DEVELOPMENT REVIEW COMMITTEE (DRC) COMMENT REPORT

PROJECT NAME: Holden Ft. Lauderdale – Senior Living

CASE NUMBER: PLN-SITE-20020003

REQUEST: Site Plan Level III Review: Conditional Use - Social Service Residential Facility (SSRF) with 211 Assisted Living Units and 25 Memory Care Units, Waterway Use and associated Parking Reduction

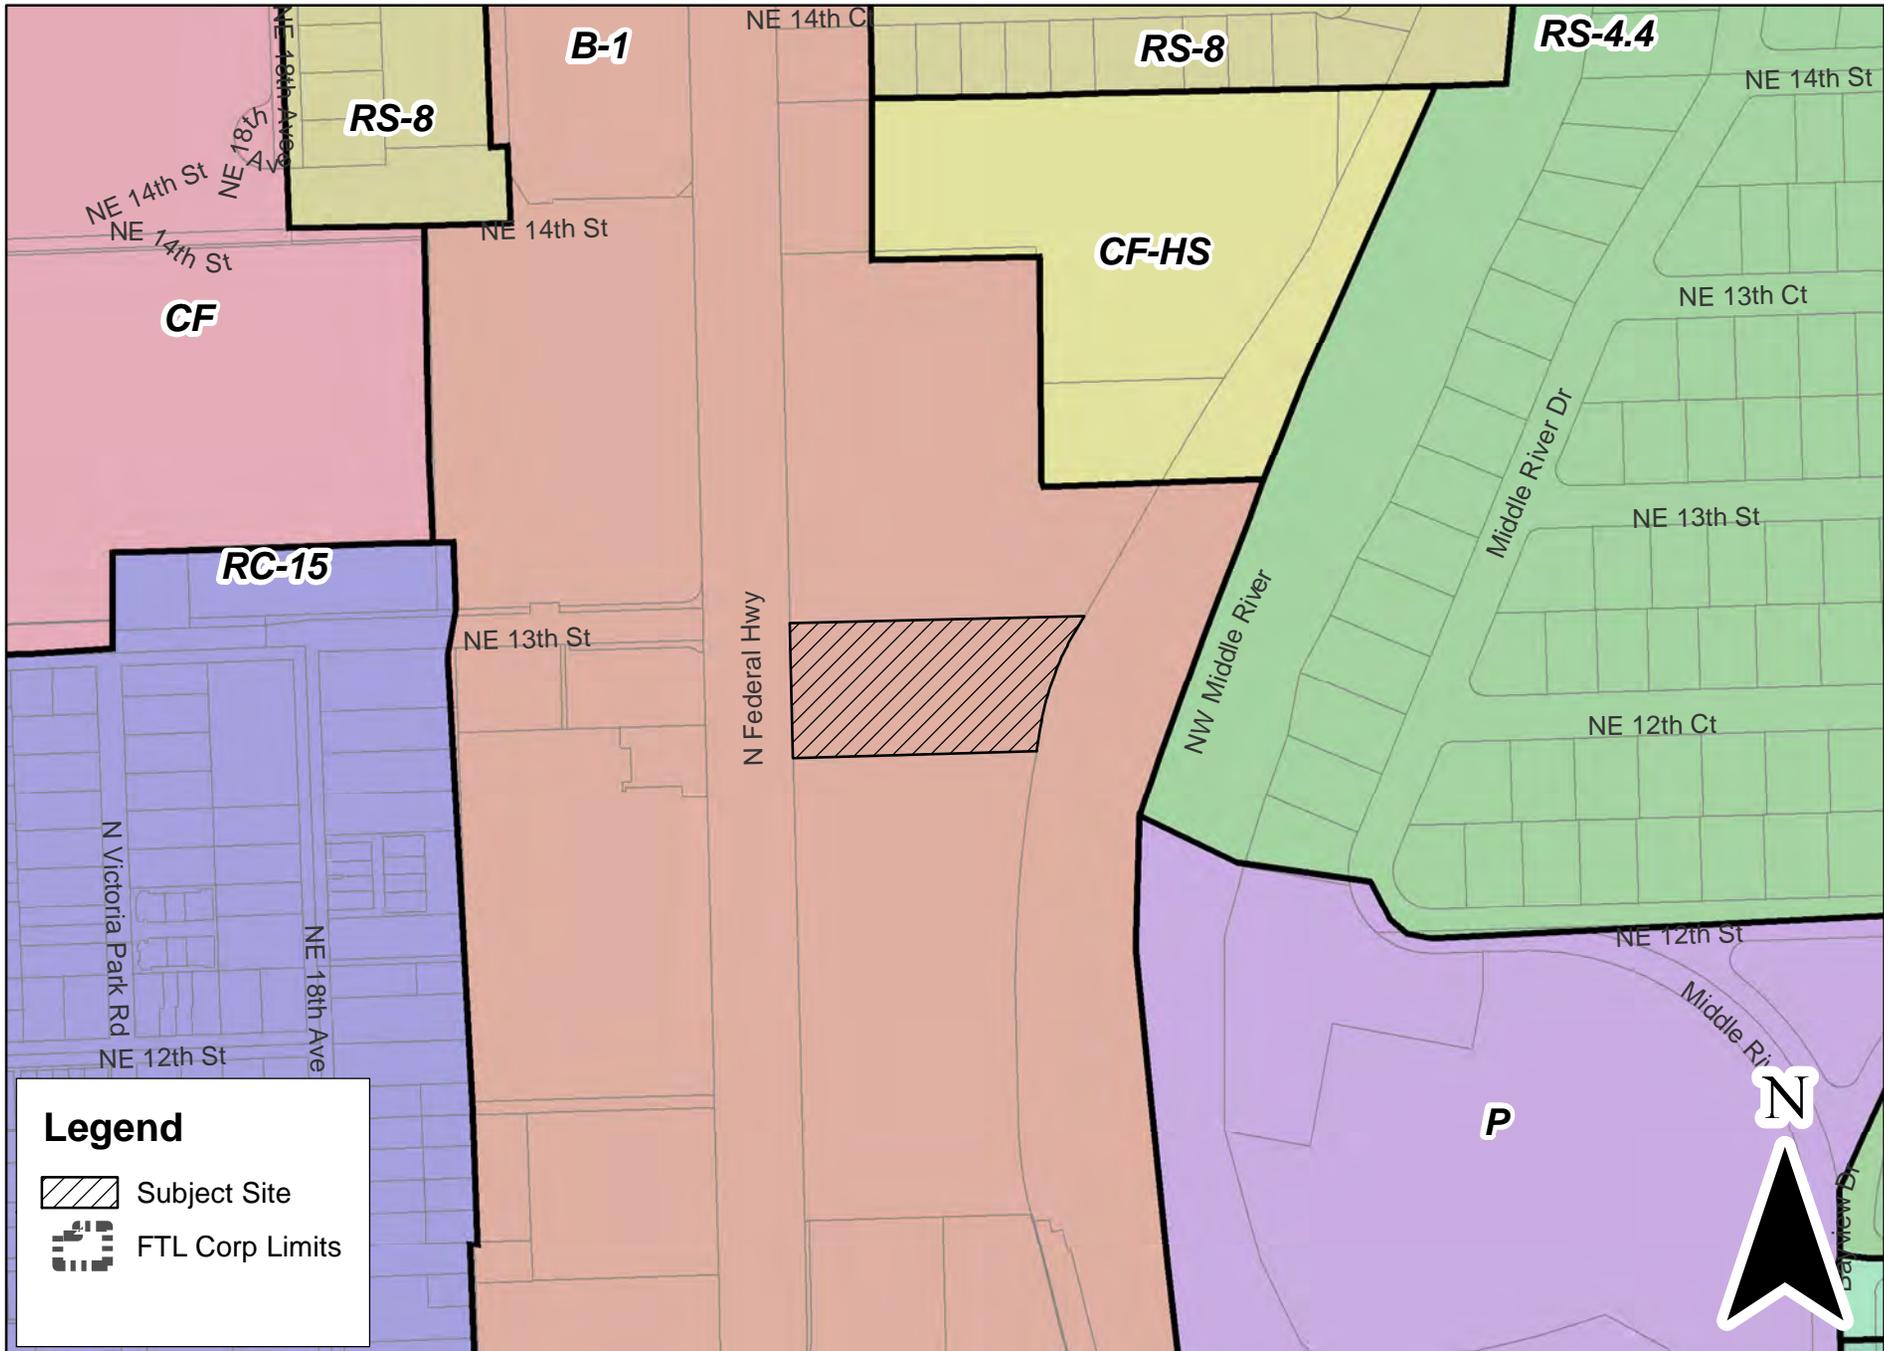
13. Pursuant to ULDR, Section 47-23.8, Waterway use, applications for development along waterways shall demonstrate that the project protects and enhances the scenic quality and tranquility of the waterway. The east-west entrance corridor along the northern property line presents an opportunity for a view corridor to the waterway and can function as a pedestrian connection to the waterfront for residents as well as activation of the ground level fronting the waterway. Provide the following changes on the site plan:

- a. Enhance the east-west sidewalk connection with a wider sidewalk a minimum of 7 feet;
 - b. Consider a sidewalk design that increases in width from west to east to provide greater visibility of the waterway;

- c. Consider creating plaza space with direct pedestrian connection to the waterfront promenade at the northeast corner of the site and provide for elements that create a sense of place;

- e. Activate the ground level of the building facing the waterway by relocating activity and function rooms to the ground level and provide connection to the waterfront promenade; and

- f. Provide elevations from the waterway at ground/water level and renderings of such. More detailed elevations and renderings may be needed.
14. Pursuant to ULDR, Section 47-23.9, Interdistrict corridor requirements, applications for development subject to interdistrict corridor requirements shall demonstrate that the project provides a spatial framework supportive of a pedestrian and multi-modal transportation environment along Federal Highway. Such framework shall encourage the direct pedestrian access from sidewalk to development

and contain elements such as seating areas, shade structures, plaza elements, and open space. Given the frontage of the property contains an FPL easement, certain elements stated above may not be permitted. Provide documentation from FPL granting approval for proposed site design.
